TYPE: TR/technical required ER/editorial required GR/general required T/technical E/editorial G/general COMMENT STATUS: D/dispatched A/accepted R/rejected RESPONSE STATUS: O/open W/written C/closed U/unsatisfied Z/withdrawn SORT ORDER: Page, Line Pa **1** Li **24**  Page 1 of 124 8/31/2016 3:49:34 PM

C/ 00	SC O	P <b>4</b>	L 19	# 134
Grow, Rober	rt	RMG Cons	sulting	
Comment Ty	vpe ER	Comment Status D		Editorial
Obsolete	e front matter d	locument list.

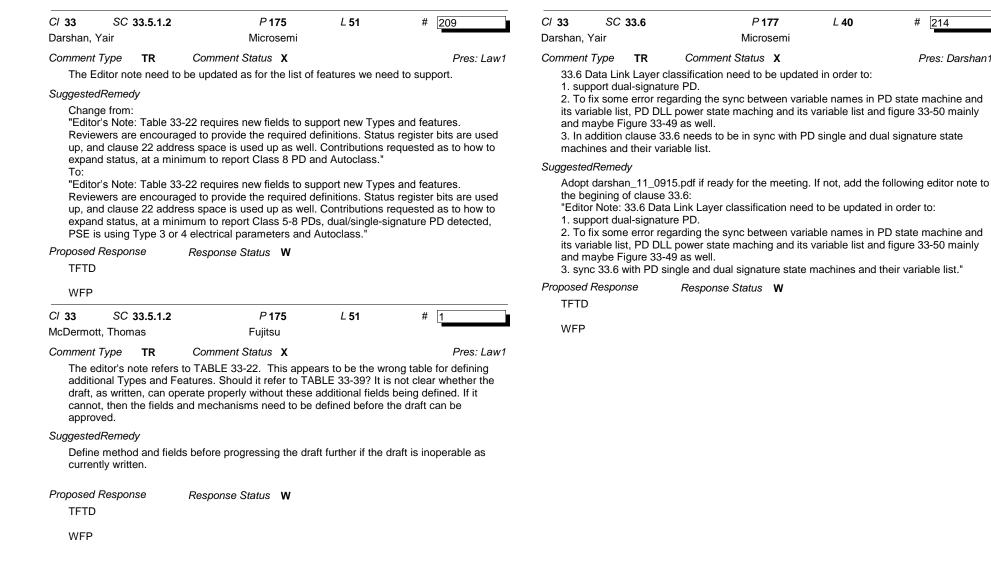
The Editor's note highlights a technical incompleteness that should have disqualified the draft from progressing to WG ballot. While it is admirable to highlight input being needed from WG members, this should have been done prior to ballot.

Unfortunately, I don't think I have a solution for you, but you need one prior to the next recirculation. All that occurs to me is to deprecate the use of Clause 22 registers, require the use of Clause 45 registers (possibly including the mapped Clause 22 registers, and get the extra registers and bits in the Clause 45 register space.
